SUBJECT: AMENDMENT NOS. 136 AND 121 TO FACILITY OPERATING LICENSE NOS. DPR-58
AND DPR-74: (TAC NOS. 75798 AND 75799)

SUBJECT: AMENDMENT NOS. 136 AND 121 TO FACILITY OPERATING LICENSE NOS. DPR-58
AND DPR-74: (TAC NOS. 75798 AND 75799)

Amendment No. 136
License No. DPR-58

SAFETY EVALUATION BY THE OFFICE OF NUCLEAR REACTOR REGULATION
RELATED TO AMENDMENT NO. 136 TO FACILITY OPERATING LICENSE NO. DPR-58
AND AMENDMENT NO. 121 TO FACILITY OPERATING LICENSE NO. DPR-74
INDIANA MICHIGAN POWER COMPANY
DONALD C. COOK NUCLEAR PLANT, UNIT NOS. 1 AND 2
DOCKET NOS. 50-315 AND 50-316

Figure 5.6-1: Donald C. Cook Nuclear Plant Schematic for Fuel Storage Racks Interface Boundary Between Regions 1 and 2

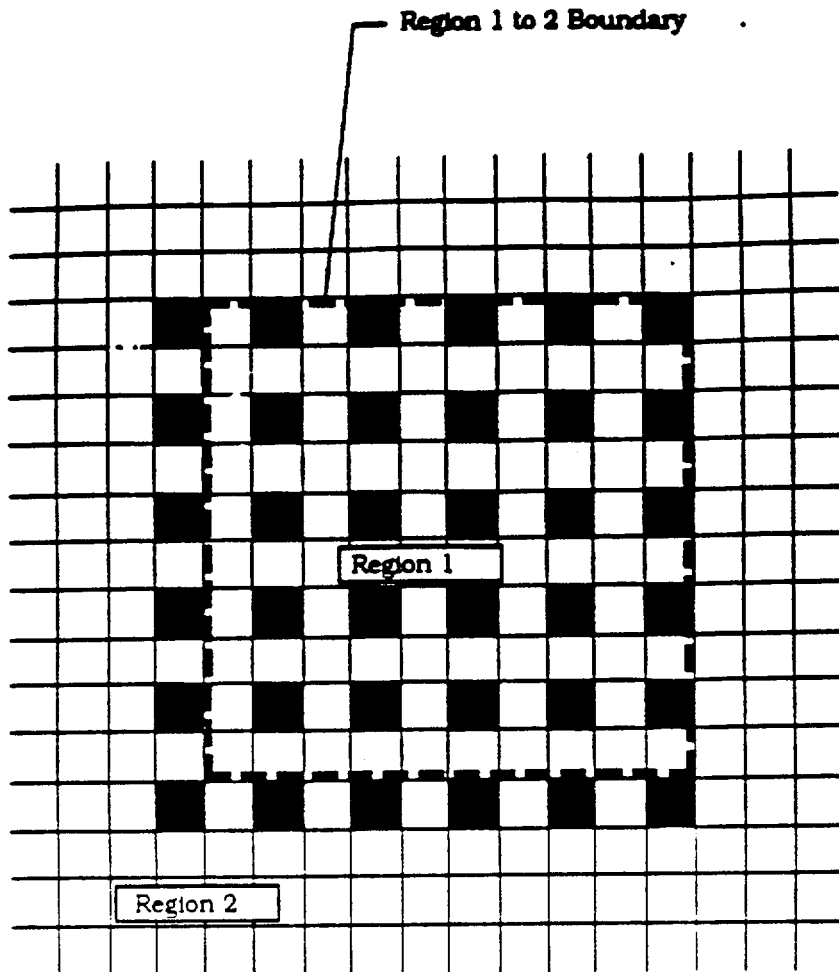
- b. A nominal 10.5 inch center-to-center distance between fuel assemblies placed in the storage racks.
 - c. 1. A separate region within the spent fuel storage racks (defined as Region 1) shall be established for storage of Westinghouse fuel with nominal enrichment above 3.95 weight percent U-235 and with burnup less than 5,550 MWD/MTU. In Region 1, fuel shall be stored in a three-out-of-four cell configuration with one symmetric cell location of each 2 x 2 cell array vacant.

2. The boundary between the Region 1 mentioned above and the rest of the spent fuel storage racks (defined as Region 2) shall be such that the three-out-of-four storage requirement shall be carried into Region 2 by, at least, one row as shown in Figure 5.6-1.

This specification includes two new subparagraphs, c.1 and c.2. Subparagraph c.1 defines the criteria for the storage of fuel assemblies in the Region 1 spent fuel storage racks. Subparagraph c.2 defines the criteria for the storage of fuel assemblies on the boundary between the Region 1 and Region 2 spent fuel storage racks. These proposed additions to the specification are acceptable because they are consistent with the safety analysis.

Figure 5.6-1: Donald C. Cook Nuclear Plant Schematic for Fuel Storage Racks Interface Boundary Between Regions 1 and 2

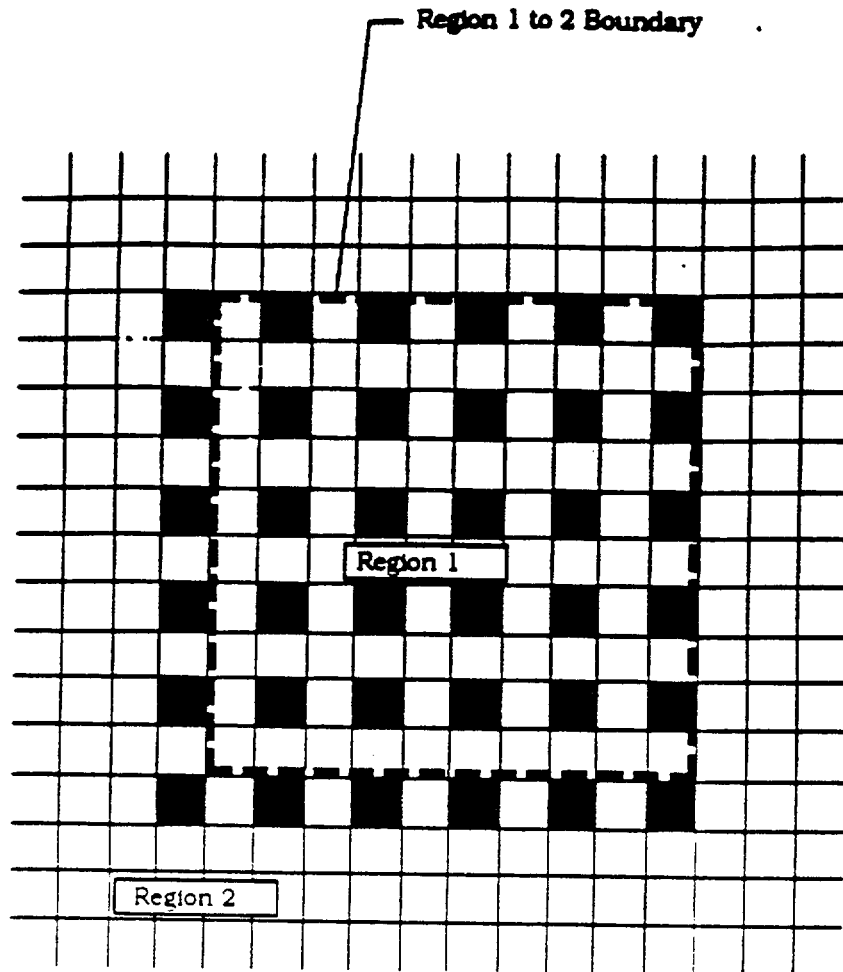
- a. A K_{eff} equivalent to less than 0.95 when flooded with unborated water,
- b. A nominal 10.5-inch center-to-center distance between fuel assemblies, placed in the storage racks.
- c. 1. A separate region within the spent fuel storage racks (defined as Region 1) shall be established for storage of Westinghouse fuel with nominal enrichment above 3.95 weight percent U-235 and with burnup less than 5,550 MWD/MTU. In Region 1, fuel shall be stored in a three-out-of-four cell configuration with one symmetric cell location of each 2 x 2 cell array vacant.
2. The boundary between the Region 1 mentioned above and the rest of the spent fuel storage racks (defined as Region 2) shall be such that the three-out-of-four storage requirement shall be carried into Region 2 by, at least, one row as shown in Figure 5.6-1.
